NUCLEAR REGULATORY COMMISSION

Title: Advisory Committee on Reactor Safeguards  
US-APWR Subcommittee

Date: Wednesday, August 17, 2011

US-APWR SUBCOMMITTEE

## 10.2 Turbine–Generator (T/G)

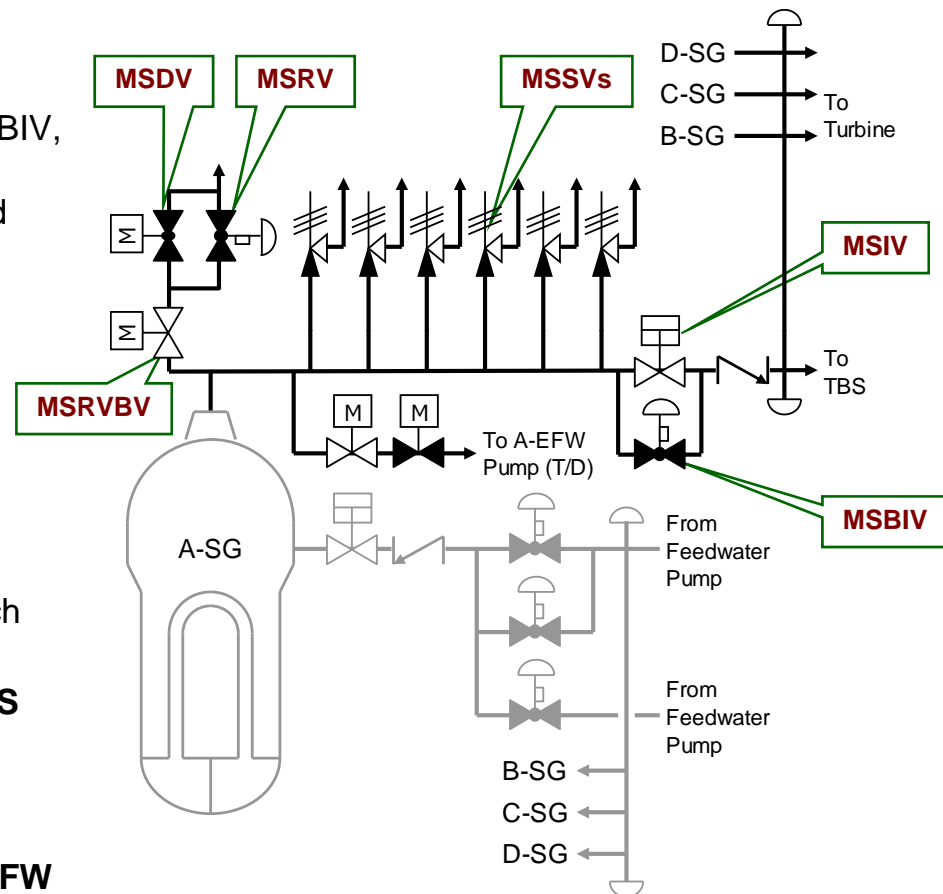
9 So, that is kind of the open question with  
10 me. I don't have any problem with the mechanical one  
11 and the figure 10.2-3, which, that shows the  
12 separation of the mechanical from the other electro-  
13 hydraulic -- or the other hydraulic part of the  
14 control system, and that looked okay.

## 10.4.4 Turbine Bypass System (TBS)

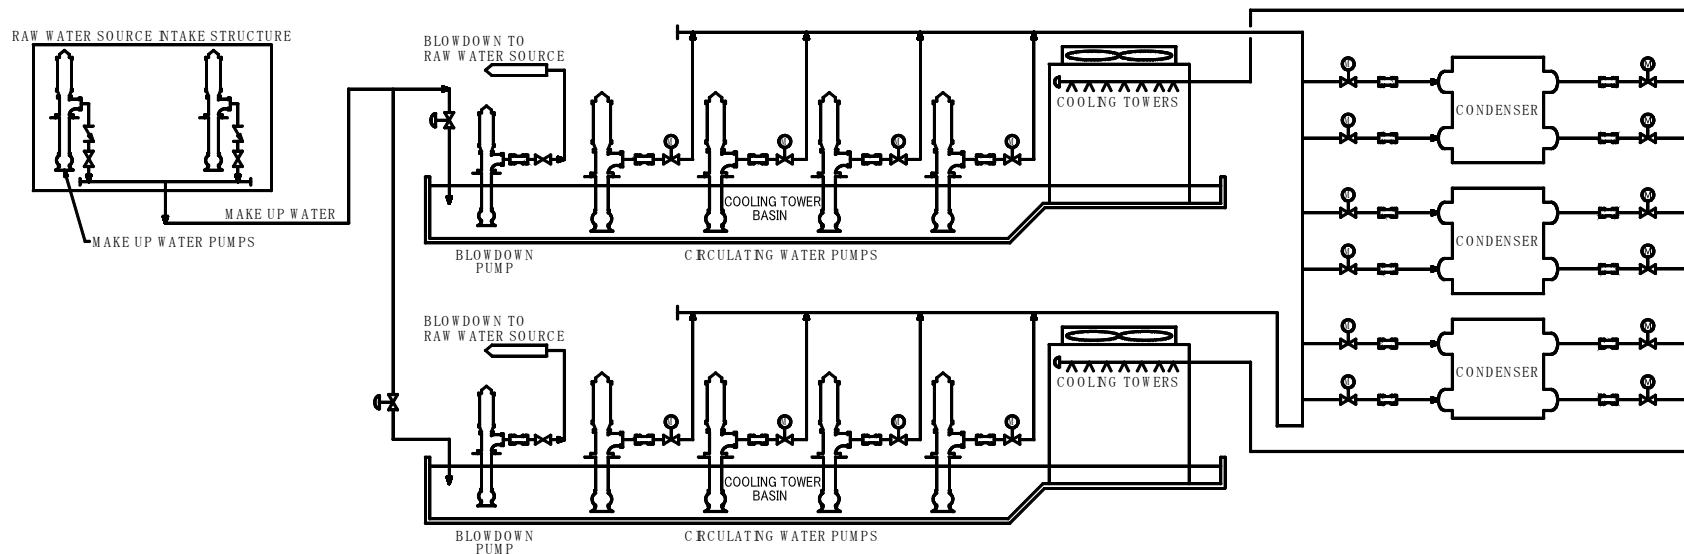
13 CHAIR STETKAR: My question is, what  
14 happens if a bank of turbine bypass valves opens,  
15 because they open fully and then modulate closed, and  
16 sticks open?

17 What happens to the plant? What  
18 protection do you have for that, and I'm not  
19 interested in hearing about separate signals that tell  
20 that same valve to close, because all of those signals  
21 are processed through the same signal process, and --

RAI No.	Question 10.04.04-X	RAI Topic / NRC Concern	RAI Response / DCD Impact
159-1955	1	-TBS capacity for the maximum step changes requirements in terms of percentage of the main steam	<div>➤ MHI provided:</div> <ul style="list-style-type: none"><li>✓ TBS has a capacity of 68 % of the rated power main steam flow</li><li>✓ TBS is designed to accommodate the maximum 100 % step change of electric load without a reactor or turbine trip and w/o the actuation of the MSRVs</li><li>✓ Three TBVs with 13.6 % of rated main steam flow perform adequate decay heat removal to keep the cooldown rate of RCS at 50 degF per hour during normal plant shutdown</li></ul>

## 08.01-1 Sharing of SSCs (Open Item)

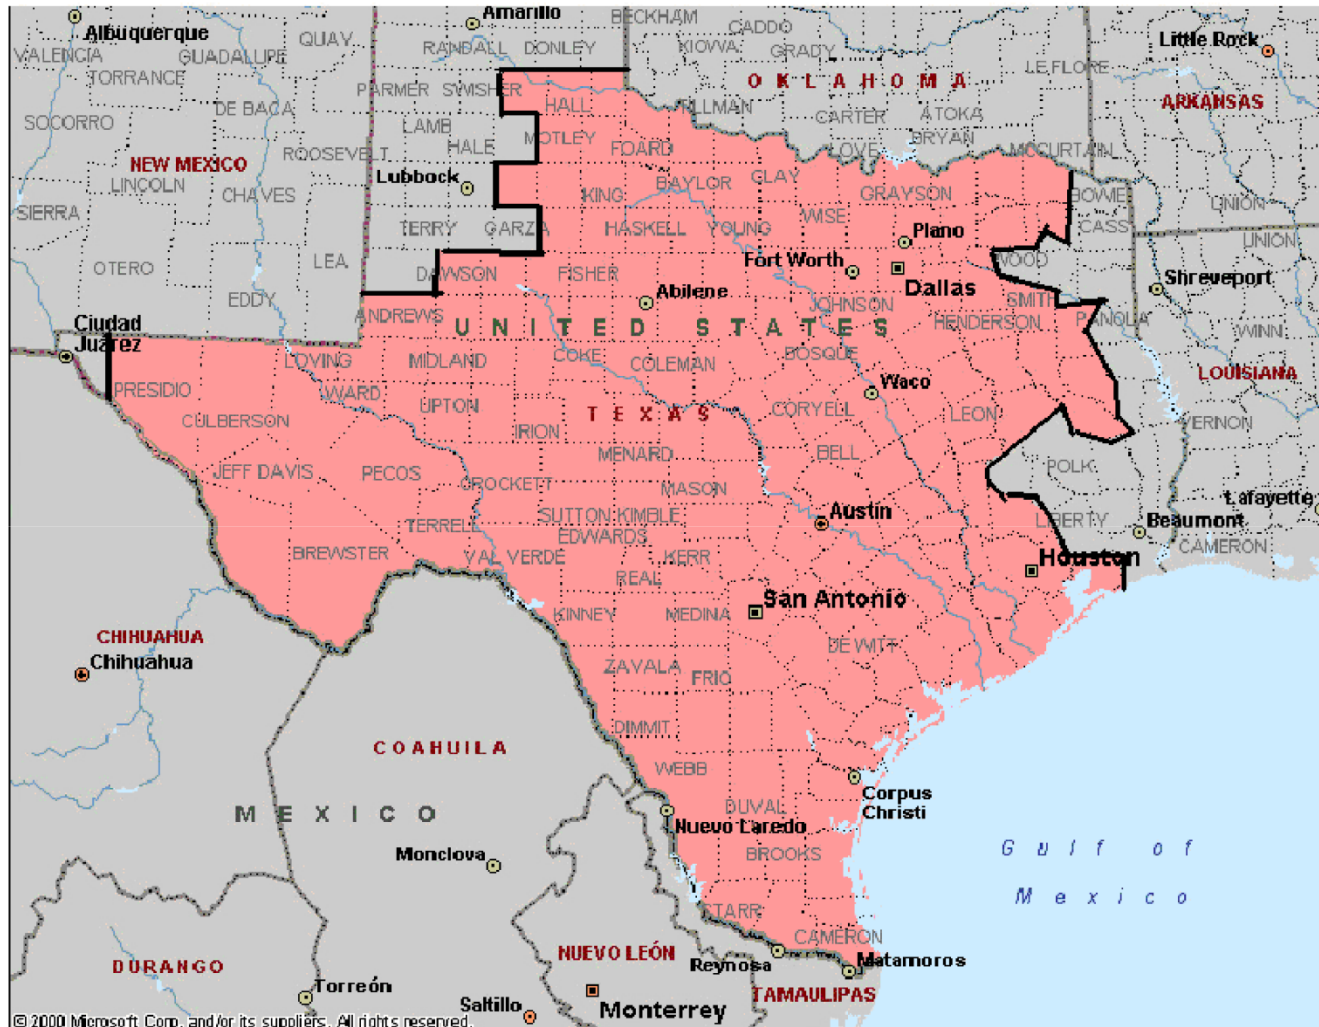
- ❑ **Open Item 08.01-1 related to CP RAI 9 (RAI 2576) Question 08.01-2**
  - “However, the applicant has not demonstrated whether or not the SSCs important to safety that are shared among nuclear power units will not significantly impair their ability to perform their safety functions, including an accident in one unit, and orderly shutdown and cooldown of the remaining units.”
  - Luminant has recently submitted supplemental information to address this Open Item and the response is under NRC Staff review.
